Southern Nuclear Operating Company
Vogtle Early Site Permit Application
Response to Request for Additional Information Involving
Limited Work Authorization-2 Supplement

Response to October 26, 2007 RAI Letter No. 9

Vogtle ESP Application Involving LWA-2

Plot of N_{60} and V_s with Elevation

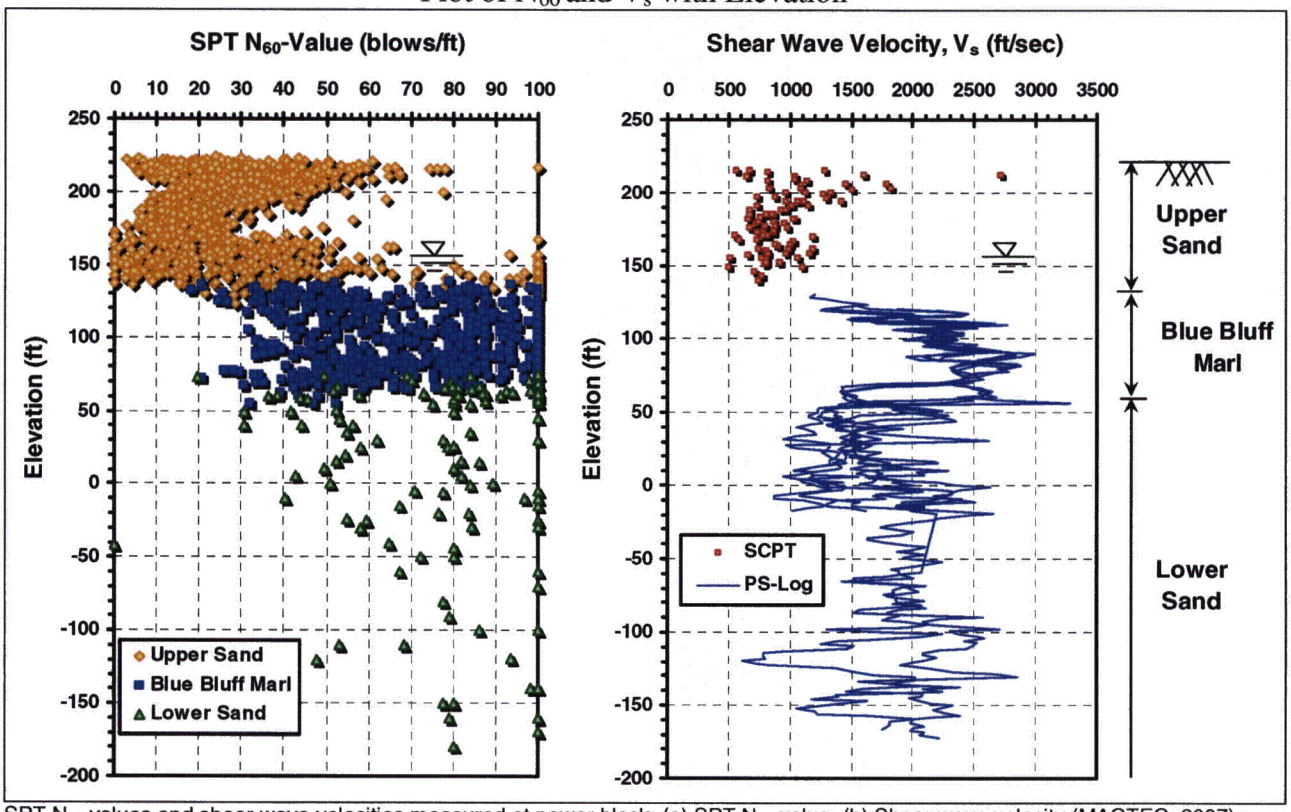
2.5.4-2 In its previous reviews conducted for the early site permit (ESP) application, the staff was concerned with the number of borings that penetrated significantly into the Blue Bluff Marl (BBM), the layer offering primary support to the Nuclear Island (NI). Without additional information concerning the depths and numbers of all these penetrations, the staff is unable to address whether the mean properties of site stratigraphy are adequately being modeled and whether enough properties were determined to be able to adequately determine material property variability; SNC is requested to provide a description of those borings that penetrated into and through the BBM and how many samples and types of samples were taken of this material as well as material below the BBM.

As stated in response to RAI 2.5.4-1, 70 borings were taken in the power block area; 42 of these borings penetrated the Blue Bluff Marl (BBM) accounting for 2,831 linear feet of drilling in this stratum. Seven hundred and forty-two SPT split barrel samples (disturbed samples) were obtained in the BBM. The SPT N_{60} values and shear wave velocity measurements in these borings are presented in the figures below. SPT blow count data are also summarized in the table below. From these SPT data, the average measured N-value is 70 bpf with a median value of 72 bpf. The average N_{60}-value is 96. Nearly all of the SPT N_{60} values from the BBM are greater than 30 bpf. Ninety-four relatively undisturbed samples were taken in the BBM. Laboratory tests were conducted on selected disturbed and undisturbed samples. A summary of these test results is also provided in the table found on page 6.

Shear Wave Velocity Measurements in the Upper Sand Stratums Measured by COL SCPTu

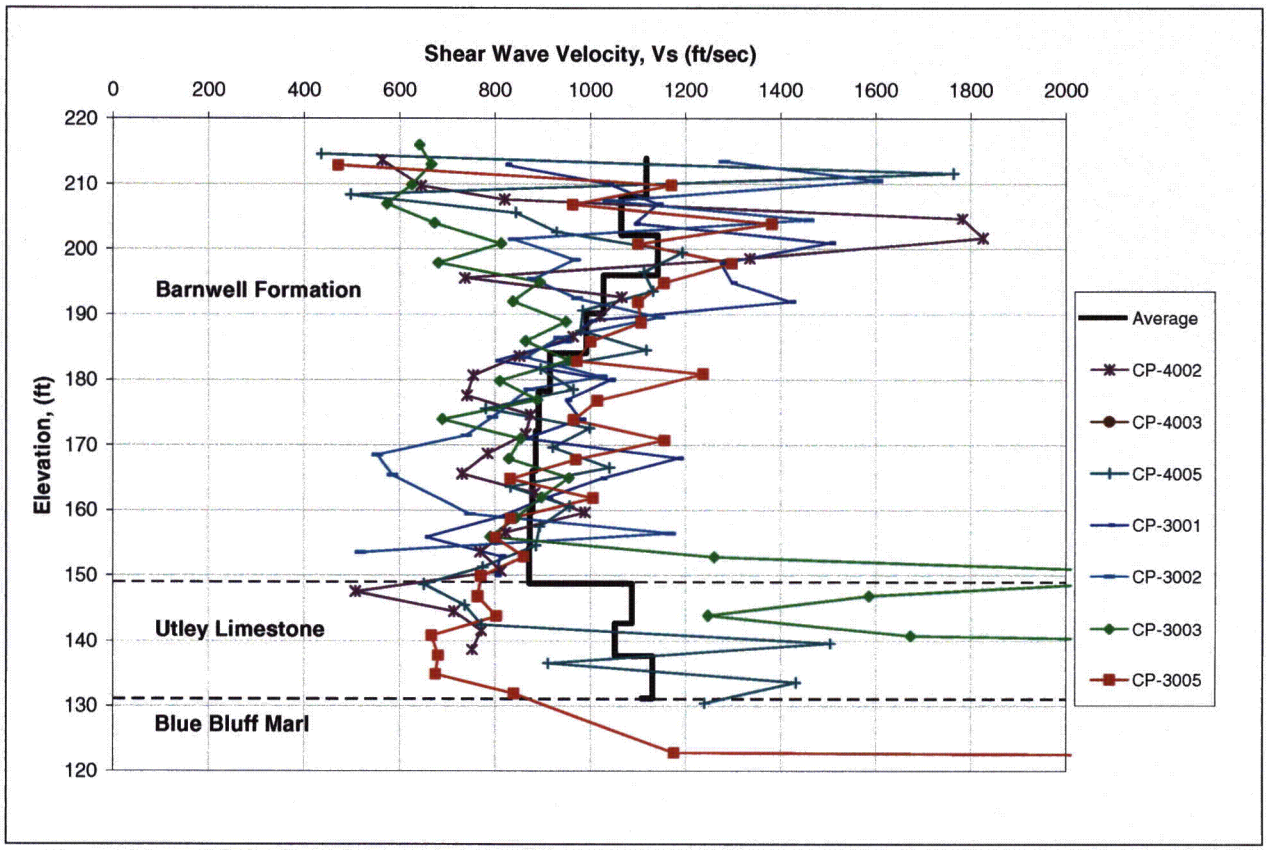
2.5.4-4 Section 2.5.4.2.2.1 indicates that no new strength (and presumably stiffness) testing is to be performed for the Upper Sand Strata since this material is being excavated from beneath the Category I structures. Without additional information, the staff cannot verify SNC's conclusion on the effect of the two-dimensional velocity configuration of the excavated zone on site response and SSI effects. SNC is requested to provide the assessment of the in-situ velocity profile through the Upper Sand Strata for the staff to complete its evaluation.

Shear wave velocity data were collected in the Upper Sand in the power block/cooling tower area. Eight SCPTu soundings were taken as described in the above response to RAI 2.5.4-1. The shear wave velocity measurements from seven of these soundings along with the average velocity profile are presented on the figured below. The data from the eighth sounding, C-4001, was not plotted and incorporated into the average value. In this sounding velocity values of 4,000 fps were encountered at the top and bottom of the US stratum and the data were judged to be unreliable.

Modulus Reduction Curves for EPRI and SRS Models

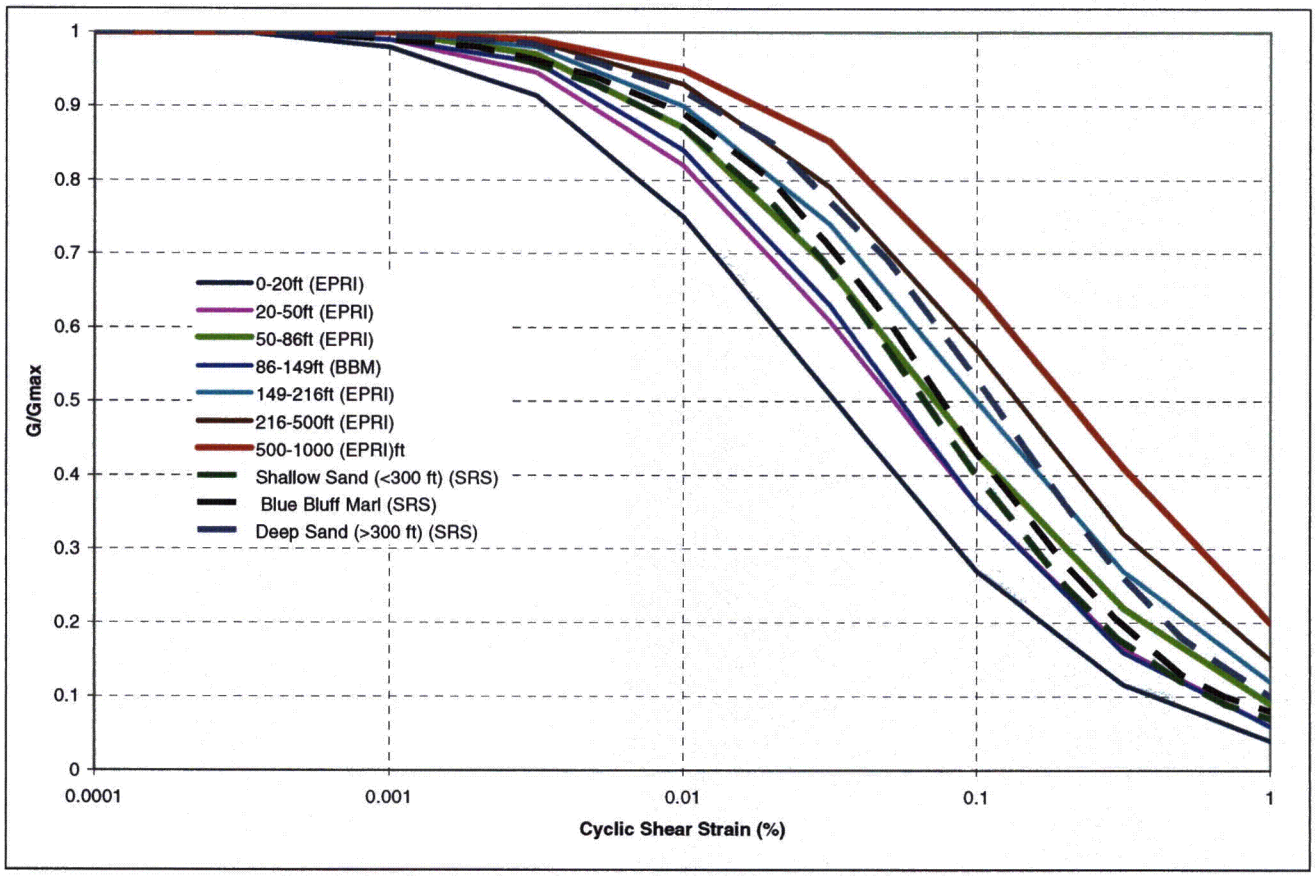
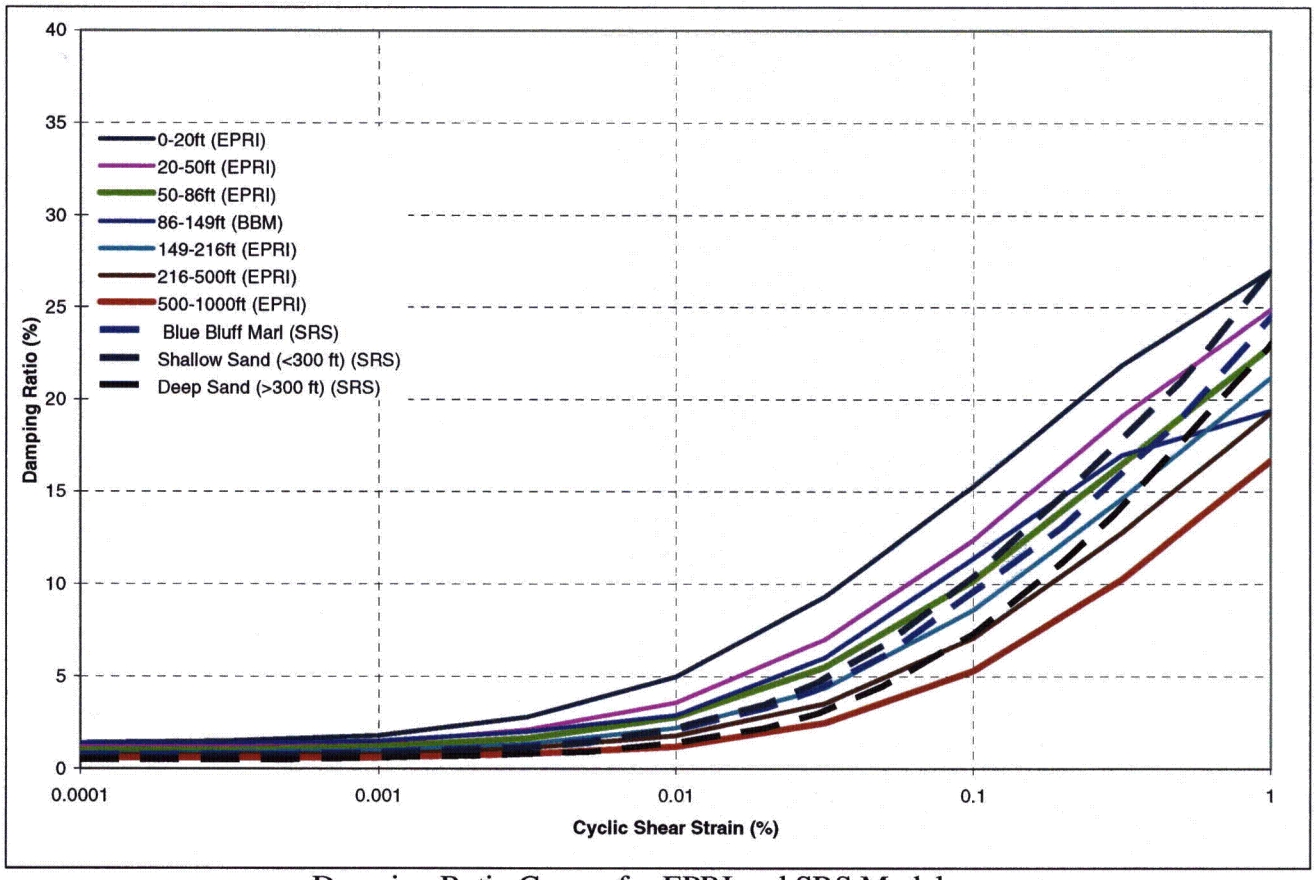
2.5.4-16 In Subsection 2.5.4.7.1, SNC discussed the shear wave velocity profile to characterize the site, but the discussion did not cover the backfill material. In Subsection 2.5.4.7.2, SNC described EPRI 1993 soil degradation models as well as SRS models. However, no significant discussion is presented of how these two models compare, which is more appropriate to use for Vogtle site response analyses, and how significant the models are to both site response and SSI analyses. SNC is requested to address these three issues.

2) ESP application Subsection 2.5.4.7.2 discusses shear modulus and soil damping for the compacted backfill, BBM, and Lower Sand strata. These subjects were further discussed in the March 15, 2007 response to RAI 2.5.4-17. These discussions included descriptions of which EPRI curves were used to derive the soil degradation values for input to the SHAKE analysis. Soil degradation values from the neighboring SRS site were also used for input to SHAKE. Figures 2.5.4-9 and 2.5.4-11 in the ESP application illustrate the EPRI soil degradation values, while Figures 2.5.4-10 and 2.5.4-12 illustrate the SRS soil degradation values. The modulus reduction curves for EPRI and SRS have been plotted together in the figure below to illustrate the relationship between these models. Likewise, the same has been done for the damping ratio curves. Note that the SRS curves were selected based on their stratigraphic relationship to the Vogtle 3 and 4 site. The SRS curve labeled as Blue Bluff Marl on the figures below is

based on the Dry Branch Formation and the Santee Formation, the SRS stratigraphic equivalent to the Vogtle Blue Bluff Marl Both data sets were used to include variability in the model and each is weighted equally. RCTS testing is currently being conducted to develop site-specific data. When these data become available, the results will be evaluated and the site response analysis will be re-run if appropriate.
